Planning Commission Agenda

SUBJECT: <i>Advertised Public Meeting:</i> Review and action on a request by Dennis Hepworth for final plat approval of Fenway Estates Phase 4, a residential subdivision consisting of approximately 10.35 acres located north and west of the northwest corner of 800 North and 2000 West (Parcel No. 14-053-0119) <i>Continued from the March 5, 2019 meeting.</i>	AGENDA ITEM: 2
PETITIONER: Dennis Hepworth, Uinta Land Company Valerie Claussen, Community Development	MEETING DATE: April 2, 2019
RECOMMENDATION: To recommend to City Council the adoption of Resolution No. 15-19 , approving Fenway Estates, Phase 4 Final Plat, subject to the conditions of approval.	ROLL CALL VOTE: YES
ORDINANCE REFERENCES: Subdivision Ordinance 26-1-6 Land Use Authority subsection (1) City Council; Engineering Standards and Specifications; and Zoning Ordinance Chapter 14 – Residential, Single Family Zone (R-1-15).	
BACKGROUND: (1) The project is located in the vicinity of 800 North and 2000 West. The property is zoned R1-15. This is the fourth phase of Fenway Estates, which obtained preliminary plat approval on May 5, 2015. (2) This phase consists of 23 lots, with a slight modification

SITE PLAN

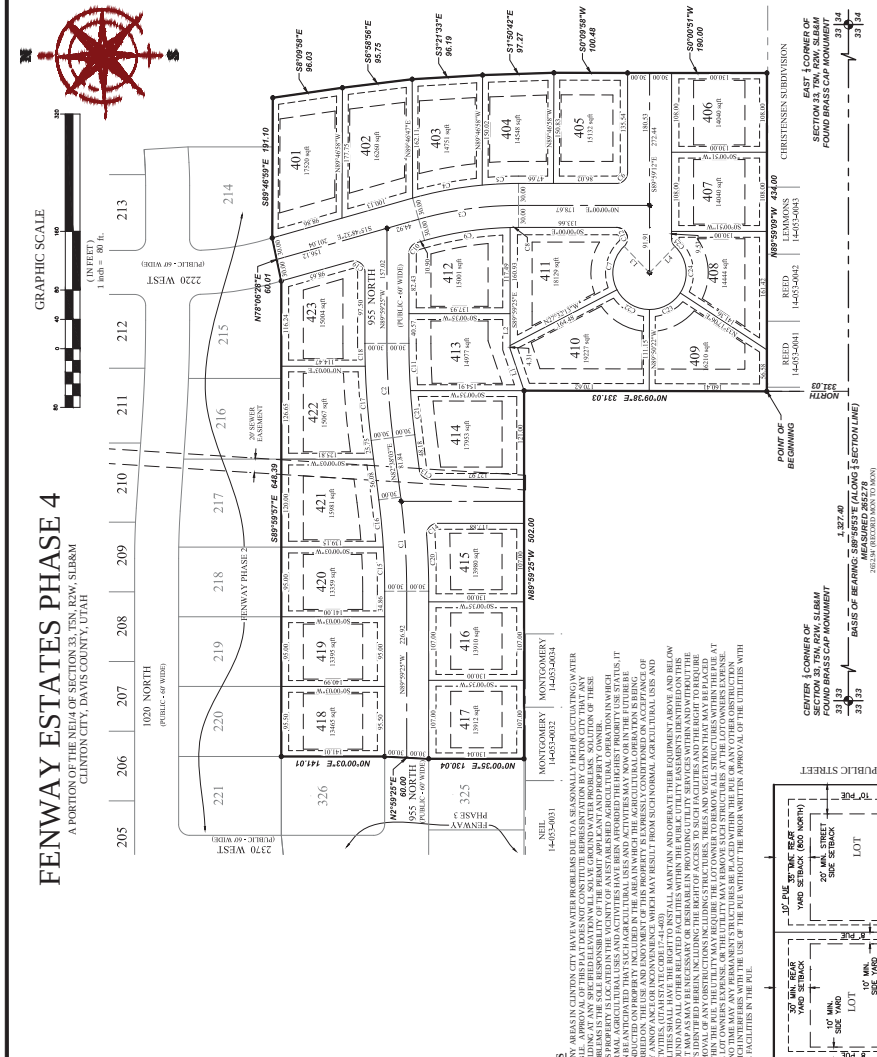
1. The boundary description does not match the boundary shown on the plat in multiple locations.
2. Lots 401, 413, 415, 418, 423 do not close
3. There is an error in curve 25 so lot 408 could not be checked.
4. There is a distance missing on the north property line of lot 410.
5. Only one street is labeled.
6. Addresses are missing.
7. The Davis & Weber Counties Canal Company signature line is missing.

#2 - Clinton City FD rejects the fire hydrant between lots 409/410. The fire hydrant needed to be moved to the South-east corner of lot 411. With 895 North being changed from a possible through street to a cul-de-sac this changed the lot shape of lot 411. Please move the fire hydrant to the South-west corner of lot 405.

The only planning comment is regarding Lot 415. Corner lots have to be a minimum of 15,000 SF in size. This one is quite a bit less than that. Corner lots also have the larger sideyard set back of 20 feet and it looks like Lot 415 is showing closer to 10 feet, whereas Lot 414 and 423 you can tell there is that larger sideyard setback.

C7

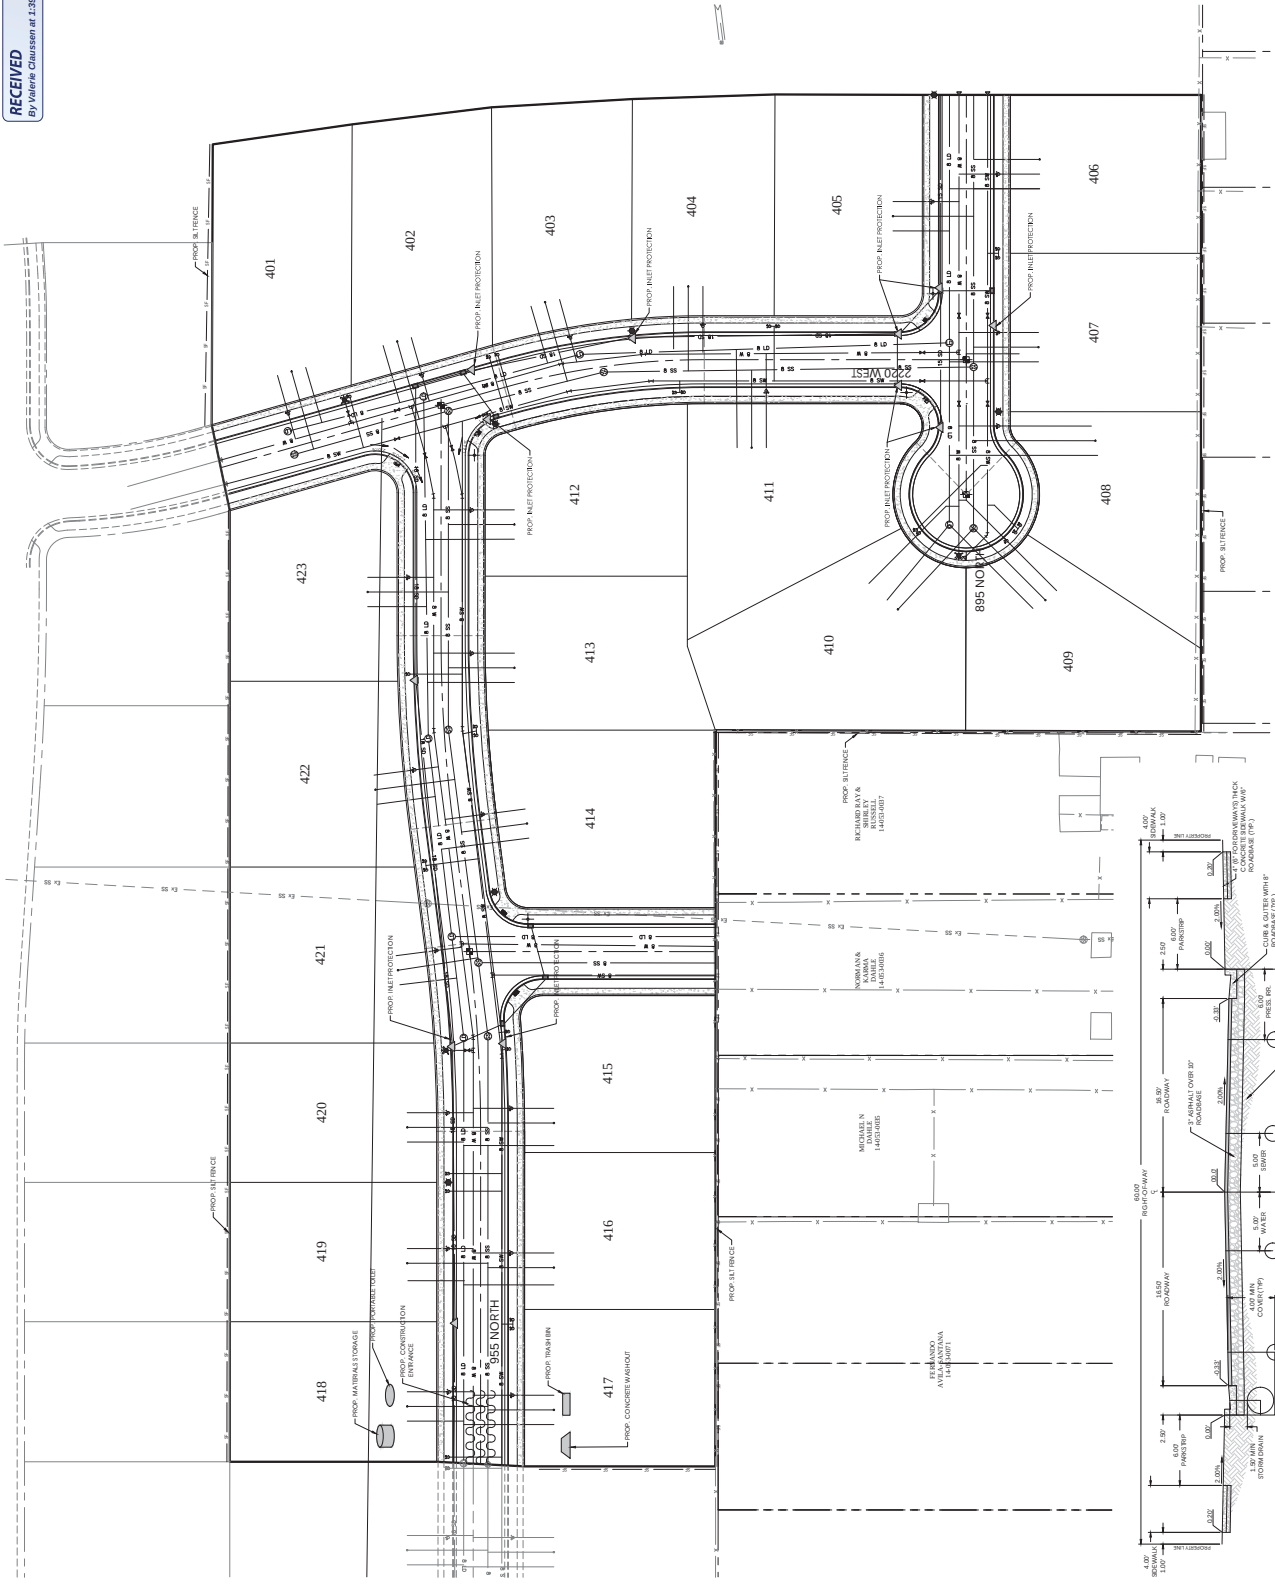
- Submittal Date: 3-13-2019
- Please submit a written response that addresses each review comment
- Put all water valves on property line- Not shown at 955N and road "A"
- Add address for road A
- Put blow offs on culinary line at all dead end streets- sht.7 if fire hydrant 103 is moved to lot 411 as per fire dept. original request, a blow off on the culinary line is needed lot 410
- Move Storm drain inlet #405 to the property line between 402 and 403.
- Move Storm drain inlet #411 to the property line between 406 and 407.
